TO: Mills City Council
FROM: Megan Nelms, AICP, City Planner
DATE: February 25, 2025
SUBJECT: Vision Beyond Borders – Development Plan

Case Number: 24.04 DEV

**Vision Beyond Borders
Commercial Development Plan**

Exhibit
Proposed Paving

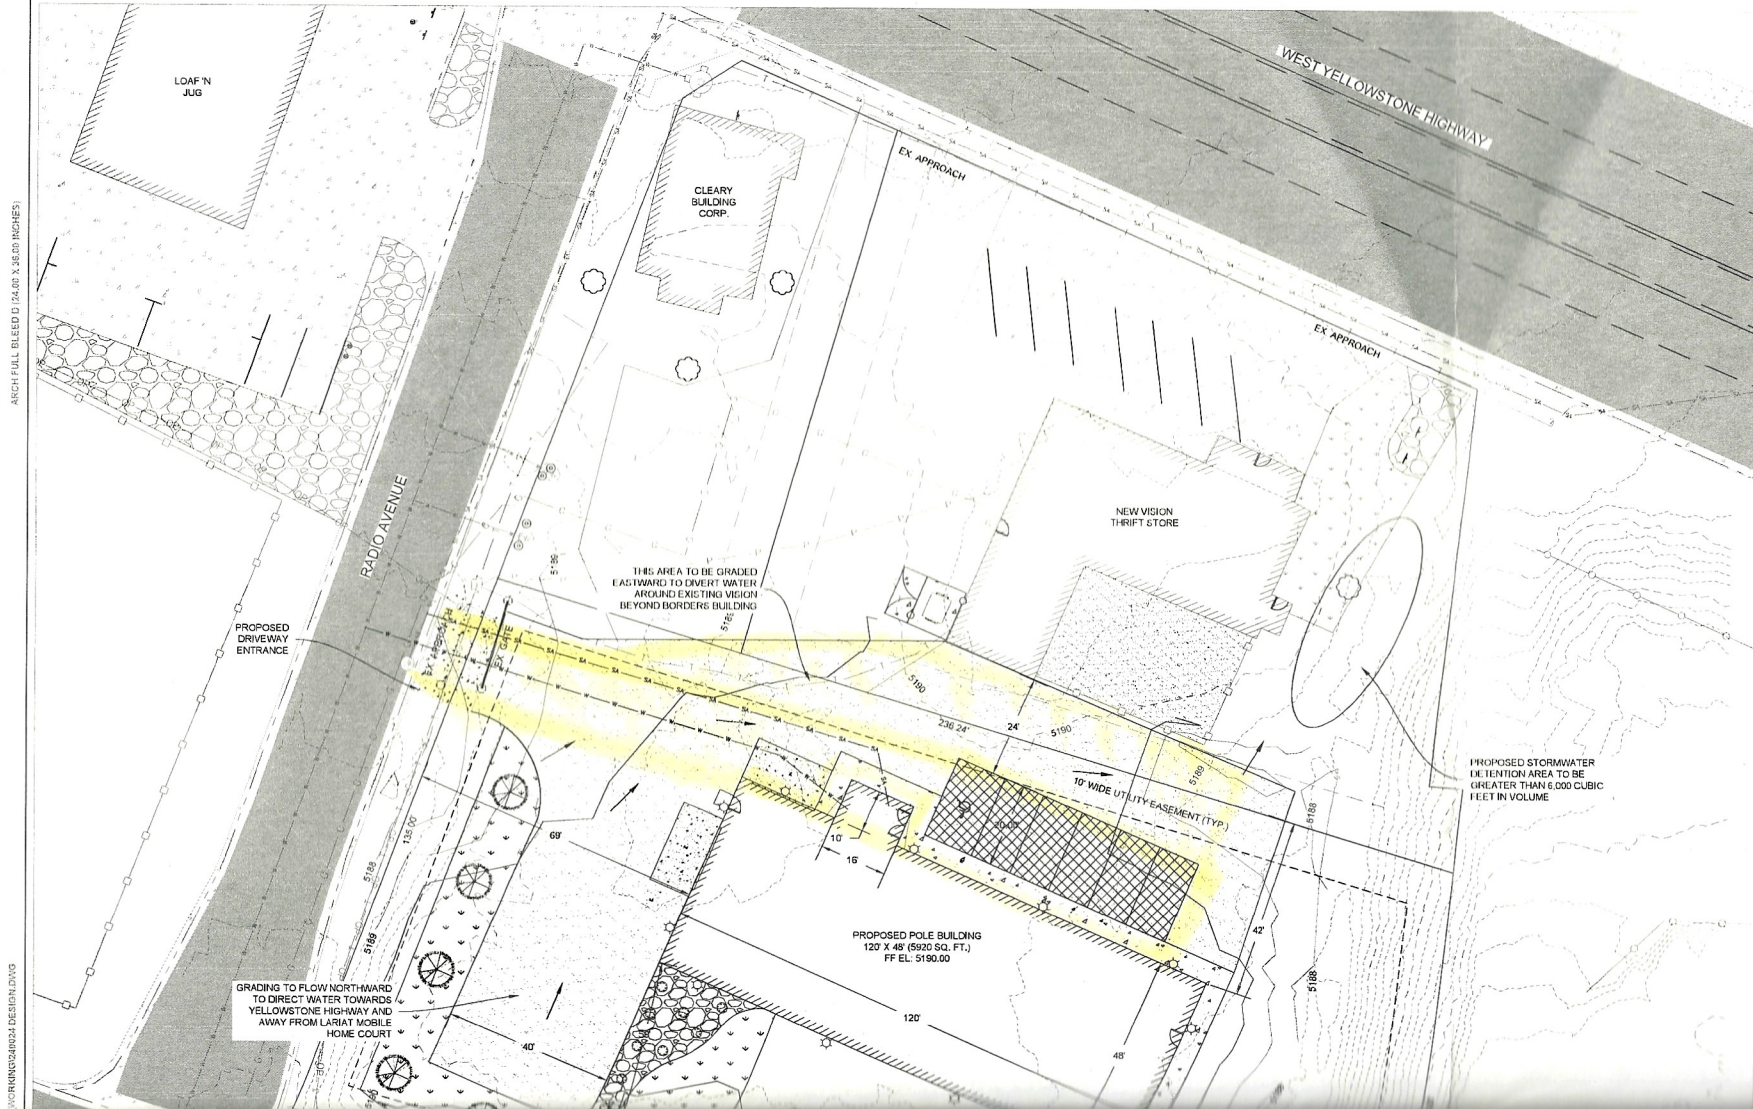
Vision Beyond Borders has made a request to be allowed to delay paving of the entire parking area. Section 40.10(14) allows the City Council to review off-street parking exception requests. VBB has requested up to five years from approval of the Development Plan to pave the parking area for the new building. The Planning Commission reviewed the request and made a recommendation to Council to allow VBB to delay paving the entirety of the parking area, however, they recommended that VBB be required to pave the required parking spaces and the drive/access aisle prior to occupancy of the building. The area recommended to be paved immediately is highlighted in yellow on the attached exhibit.

Staff Recommendation: Staff's recommendation is to require paving of all the required parking area prior to occupying the new building. All other requirements

Planning Commission Recommendation: At their February 6, 2025, meeting the Planning & Zoning Commission made a “DO PASS” recommendation on the Development Plan, pending completion of all planning considerations. Planning Commission recommends the applicant be allowed to delay paving of the entire parking area for up to 5 years but require paving of all off-street parking spaces and the access drive/aisle, as shown on the attached exhibit, prior to occupancy of the building.

**SITE PLAN
VISION BEYOND BORDERS
MILLS, WY**

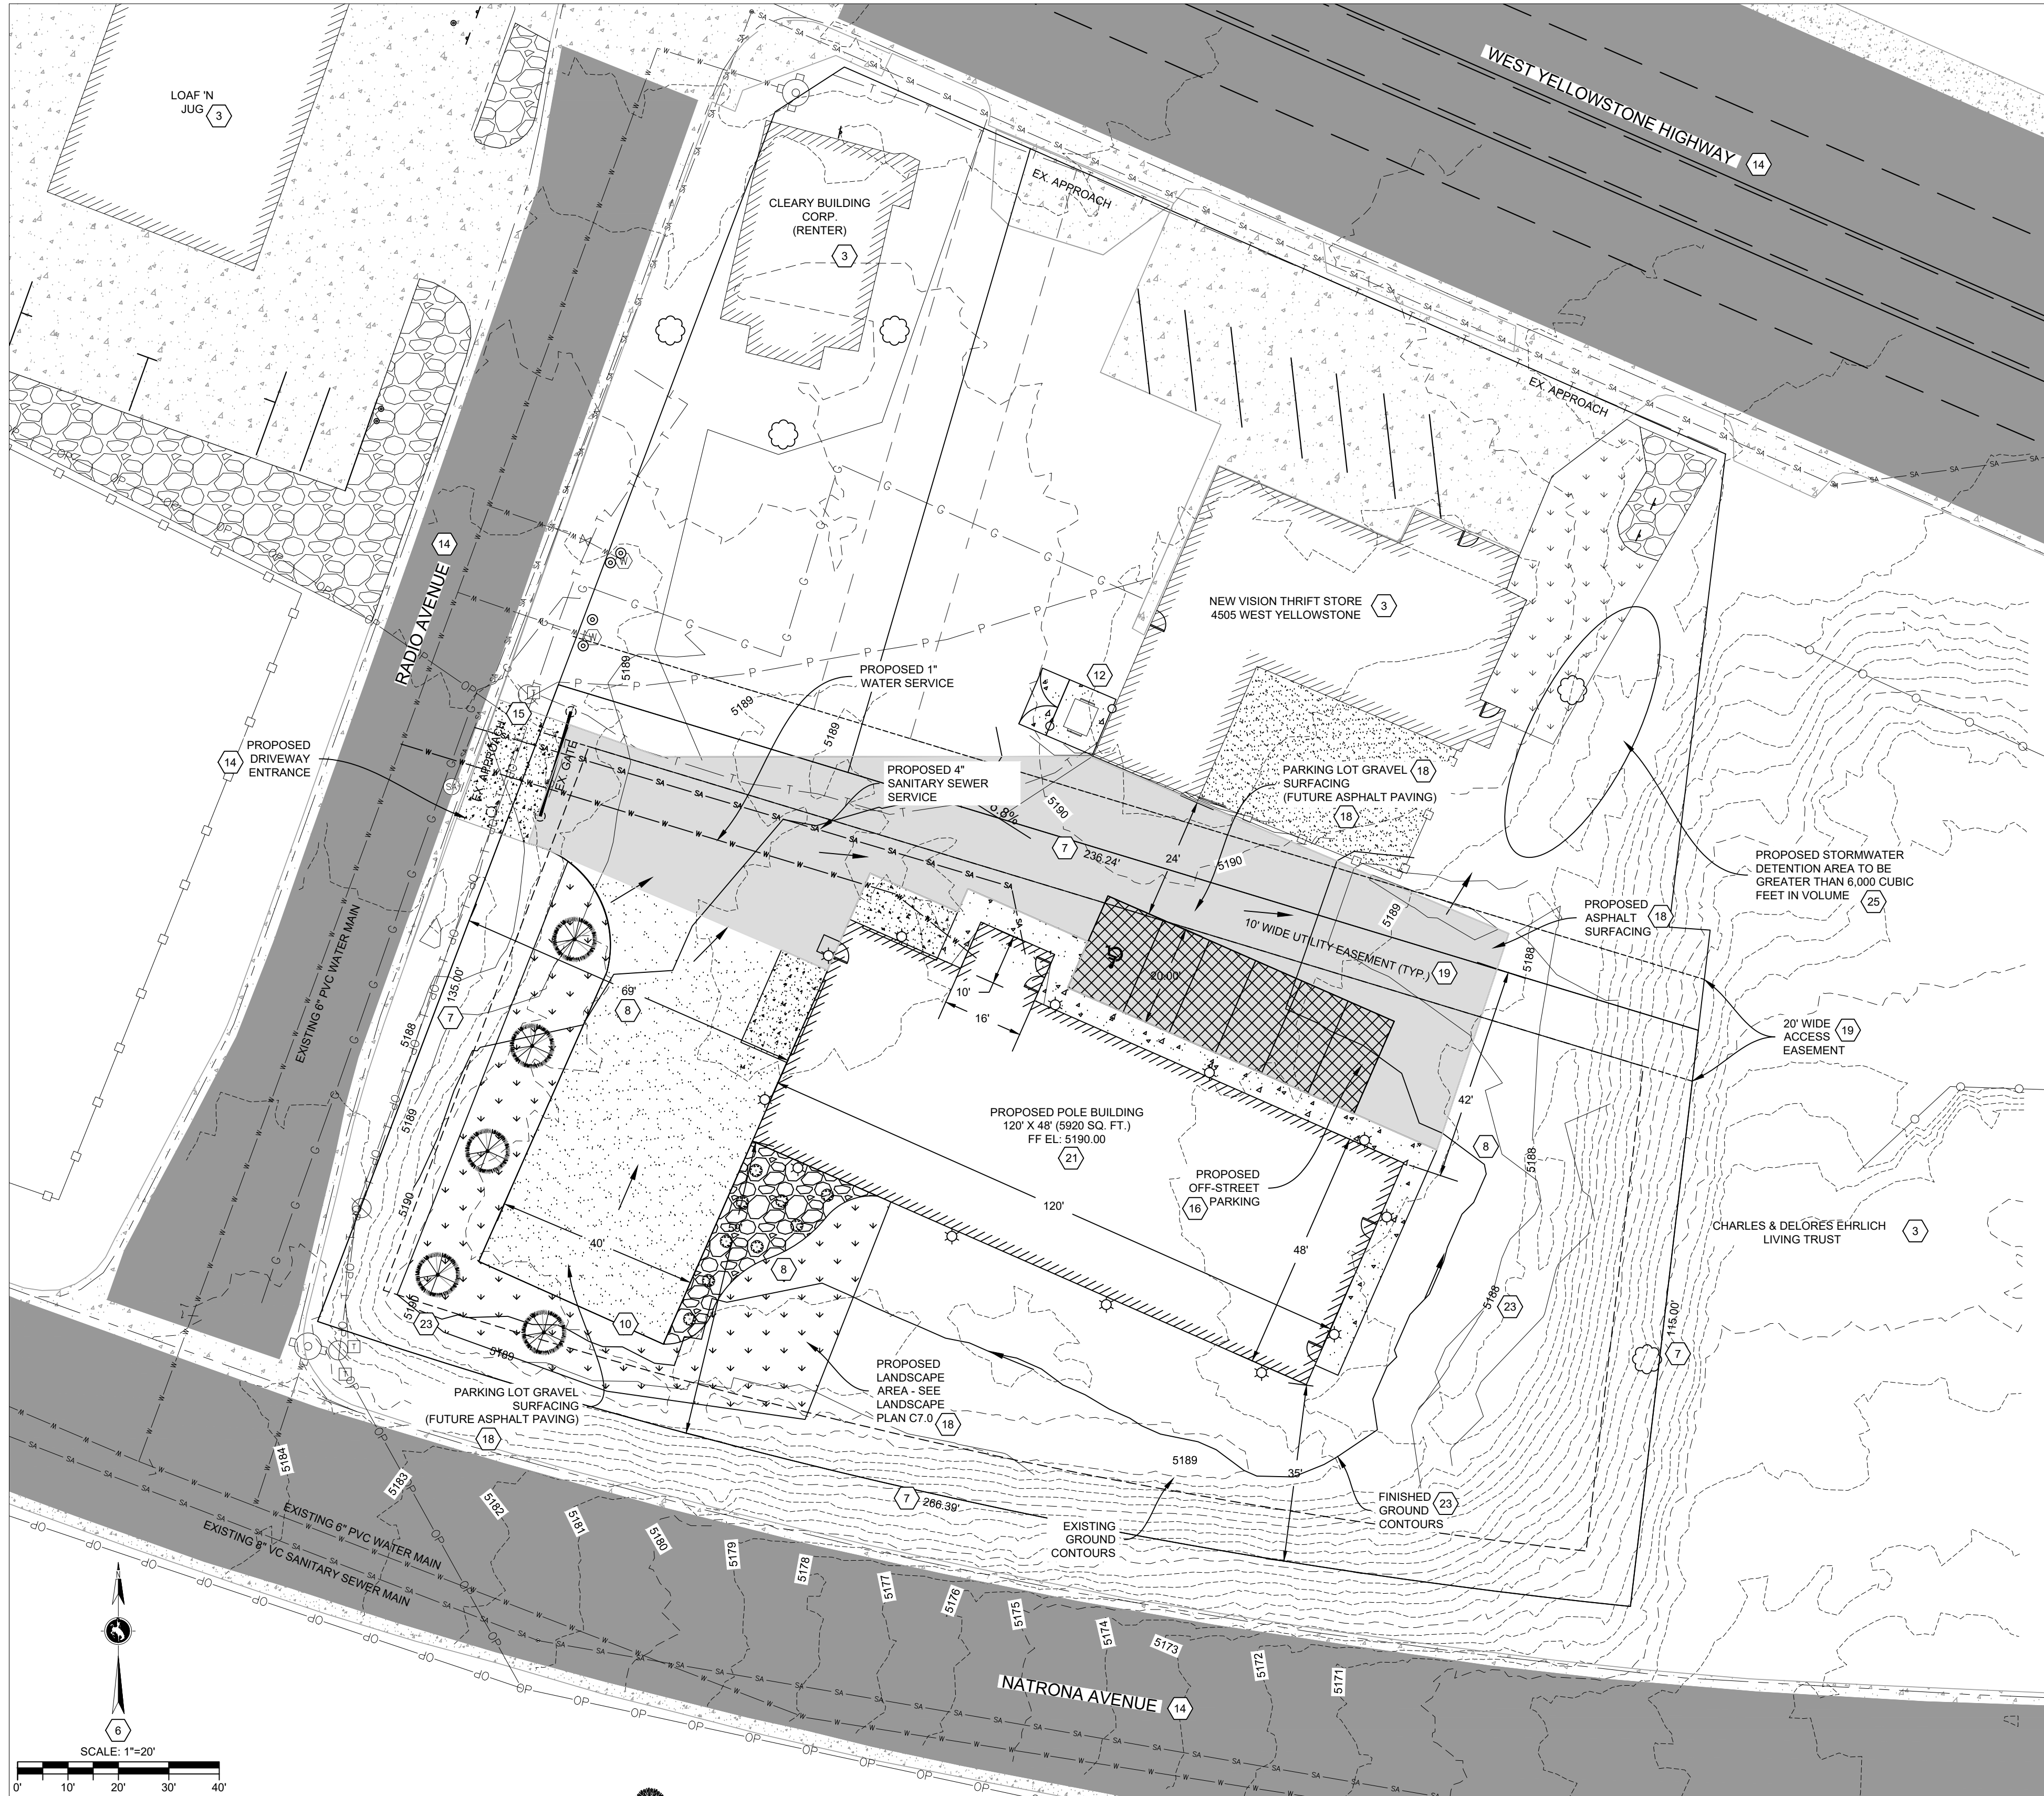
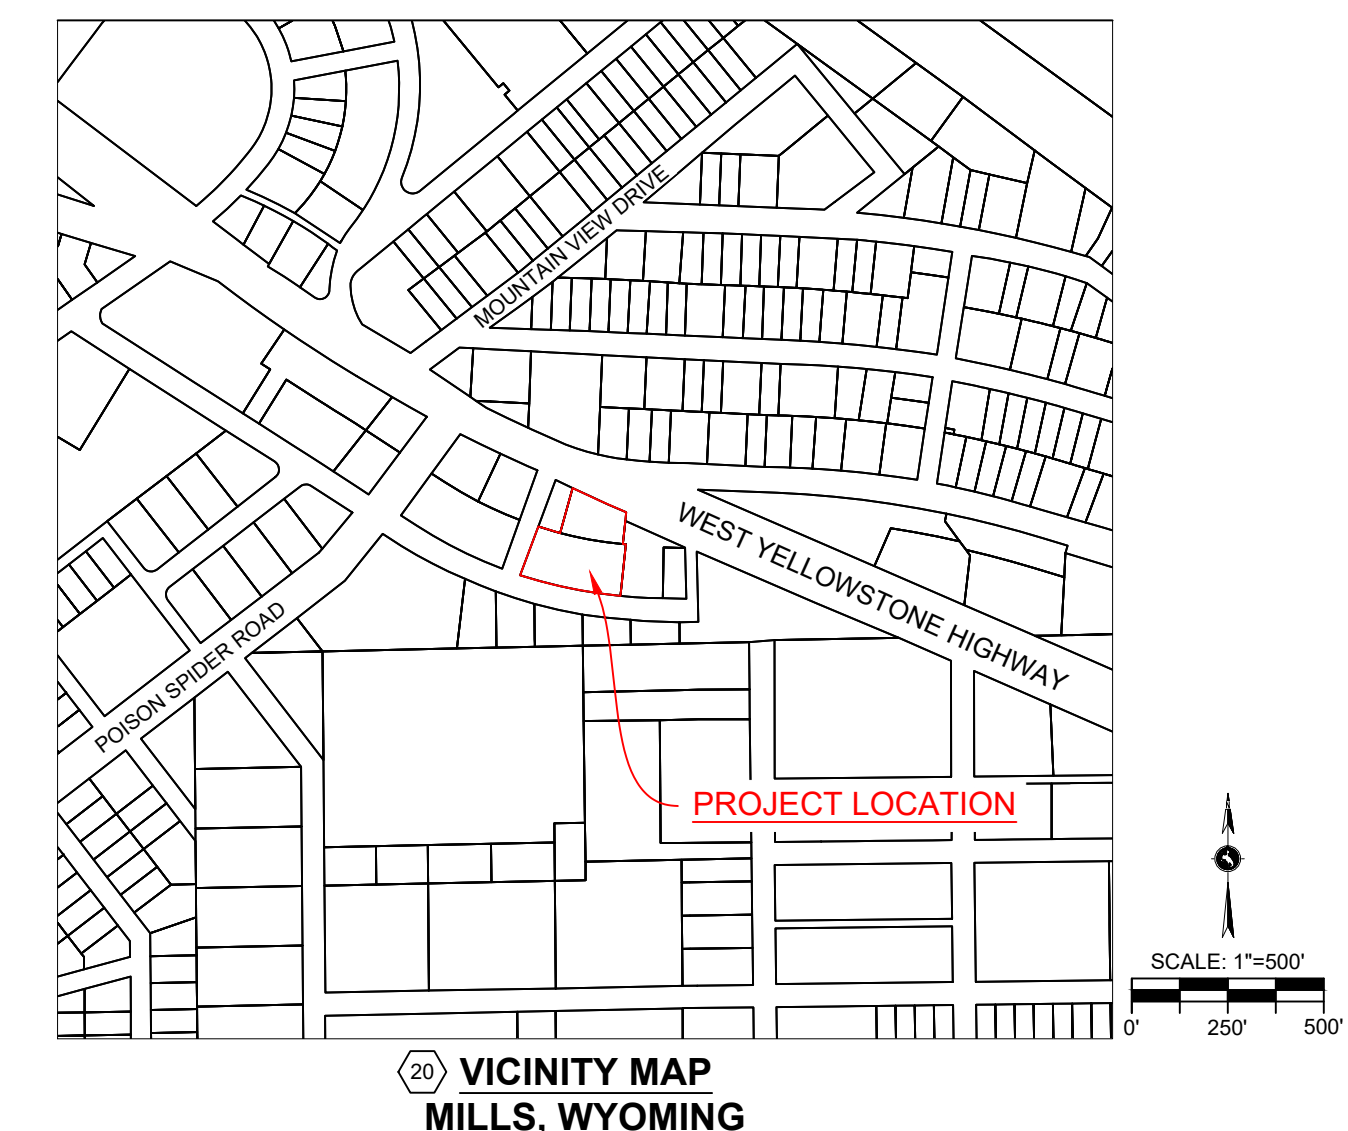
The submitted Development Plan depicts the required six (6) parking spaces as paved, however, the applicant has indicated on the Development Plan and in the application their intention to utilize gravel surfacing across the remainder of the site, with plans to pave in the future. The Commission should evaluate this request and either include a recommendation to Council to allow an exception to the paving requirement or request a revision of the application to show a fully paved surface at time of construction.

3. Per Section 40.10(6) all required parking spaces and all driveways, entrances and exits from the parking area shall be paved with asphalt, concrete or similar permanent surface.

There was general discussion about the lot lines and a shared access and utility easement shown on the plat. Board Member Bryson stated that the site plan shows vehicles on the access drive to the parking area will be crossing over the lot line a bit and he doesn't want to see any issues if there are ever two different owners of the parcels.

Chairman Gudger then asked if there were any other comments or questions from the commission. There were none. Chairman Gudger then made a motion to recommend approval of the development plan and recommend to city council to allow for a 5-year delay of paving the required parking area and only require paving of the areas highlighted in yellow on the exhibit drawn by the applicants at the time of building occupancy. His motion also included an additional planning consideration to require a shared access agreement along the east/west property line to ensure access to the new commercial building on Lot 3. Board Member Bryson seconded the motion. All voted aye, motion carried.
